TITLE: TECHNICAL REQUIREMENTS MANUAL
(UNIT 1)

REVISION NO: 006

CHANGE NO: AP-06

ARKANSAS NUCLEAR ONE, UNIT NO. 1

Figure 3.7.3-1
Spent Fuel Cooling Capacity

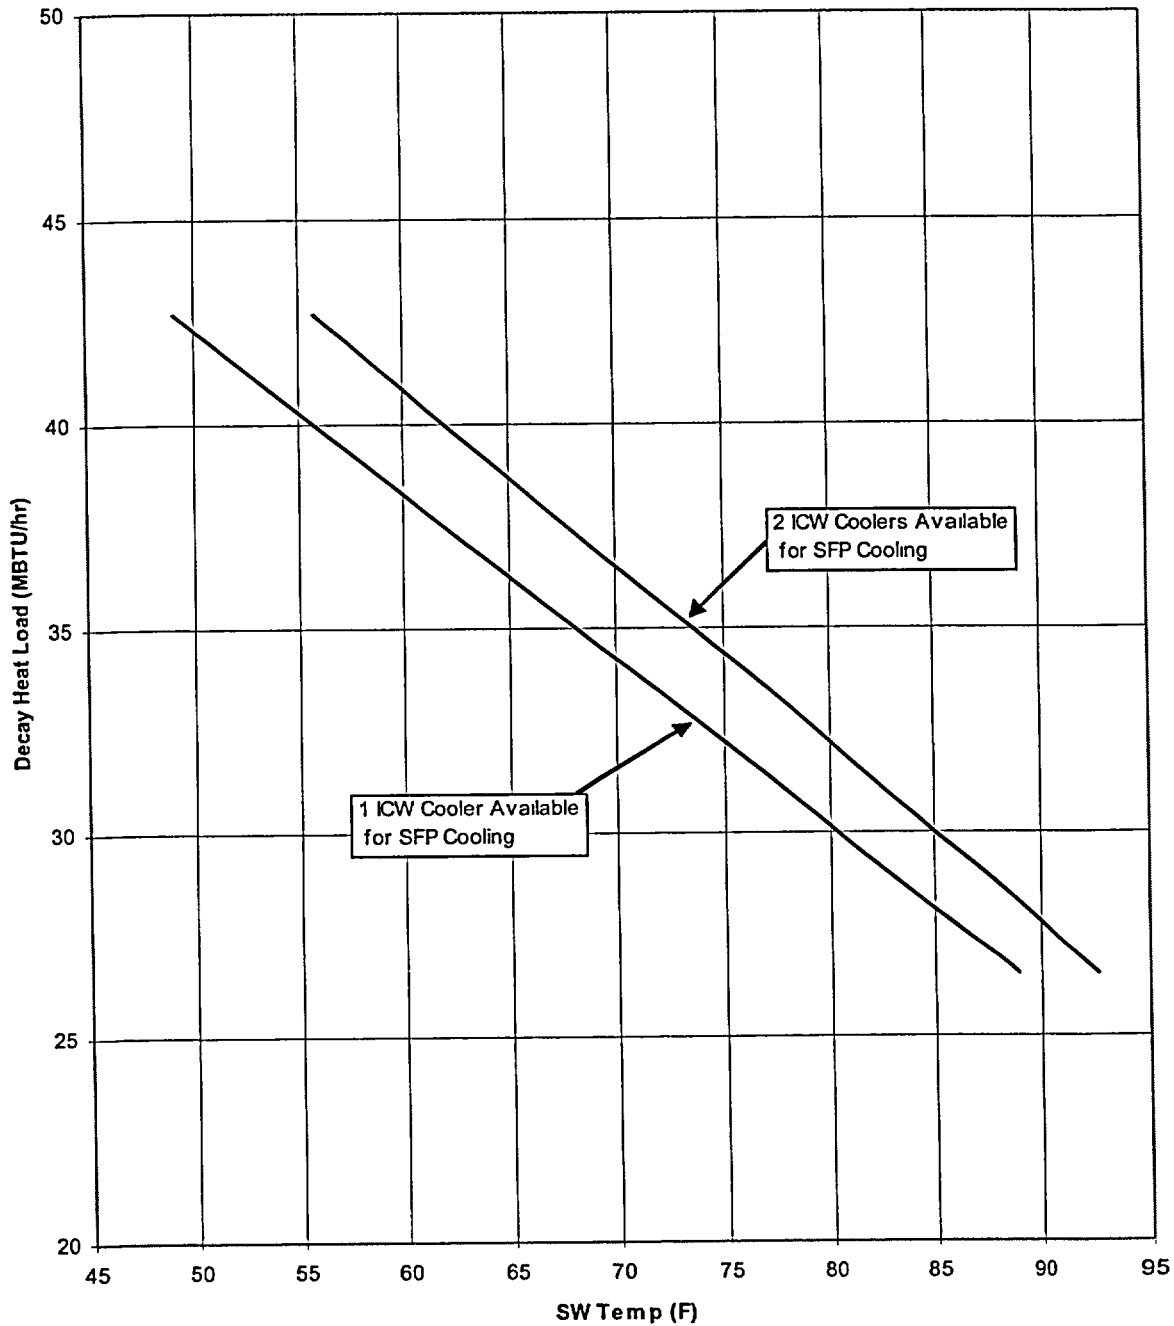
TRO 3.7.3 During full core offload, the heat load in the SFP shall remain within the limits specified in Figure 3.7.3-1.

SURVEILLANCE	FREQUENCY
SR 3.7.3.1. The sum of the total heat load to be transferred to the SFP plus the existing SFP heat load shall be determined to be less than the limits specified in Figure 3.7.3-1.	Prior to and during each full core offload.

Note: 2 SFP Cooling Heat Exchangers and Pumps are required for full core offload
